Access Compliance Report

Public Rights-of-Way

(Curb Ramps)

Intersection ID: 31301	Main Street: HOLBERT_CR	Cross Street: MUNSING_DR	Location: S
ADA ID: 87002E8C692C	Ramp Type: PerpDiag	Initial Pass/Fail: Fail	Overall Compliance: No
		Severity Score: 25

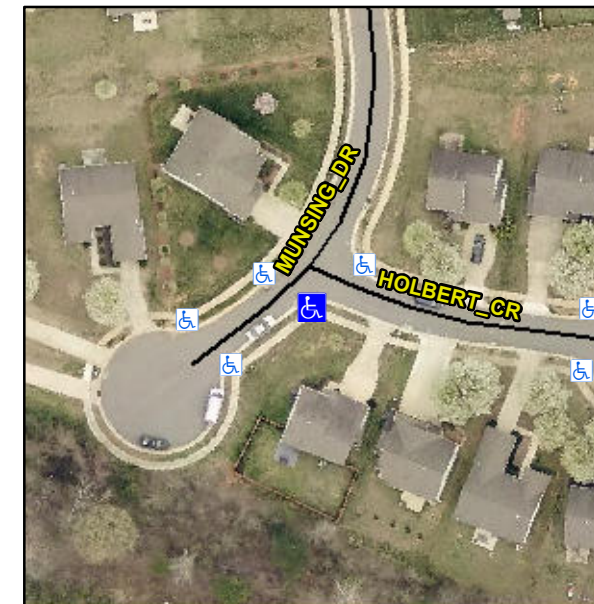
Not Found, R304.2.2

Compliance	Description	Data	Compliance	Description	Data
N/A	Ramp Length (in)	51.5	No	Ramp Slope (%)	20.0
Yes	Ramp Width (in)	48.0	Yes	Ramp XSlope (%)	0.8
N/A	Flare Type LT	N/A	N/A	Flare Type RT	N/A
N/A	Flare Slope LT (%)	N/A	N/A	Flare Slope RT (%)	N/A
N/A	Flare Traversable LT?	N/A	N/A	Flare Traversable RT?	N/A
N/A	Landing Length (in)	N/A	N/A	DWS Provided?	N/A
N/A	Landing Width (in)	N/A	N/A	DWS Contrast?	N/A
N/A	Landing Slope (%)	N/A	N/A	DWS Length (in)	N/A
N/A	Landing X Slope (%)	N/A	N/A	DWS Full Width?	N/A
N/A	Landing Curb? (Y/N)	N/A	N/A	DWS Offset (in)	N/A
N/A	Shared Landing?	N/A			
N/A	Gutter Ponding?	N/A	N/A	Gutter Slope (%)	N/A
N/A	Gutter Lip Ht (in)	N/A	N/A	Gutter X Slope (%)	N/A
N/A	Painted X Walk1?	No	N/A	Painted X Walk2?	No
	X Walk 1 Direction	To NE		X Walk 2 Direction	To NW
N/A	X Walk 1 Width (in)	N/A	N/A	X Walk 2 Width (in)	N/A
	X Walk 1 Slope (%)	3.6		X Walk 2 Slope (%)	5.7
	X Walk 1 X Slope (%)	1.4		X Walk 2 X Slope (%)	1.8

Remove & Replace Curb Ramp With Two New Directional Ramps or Equivalent.
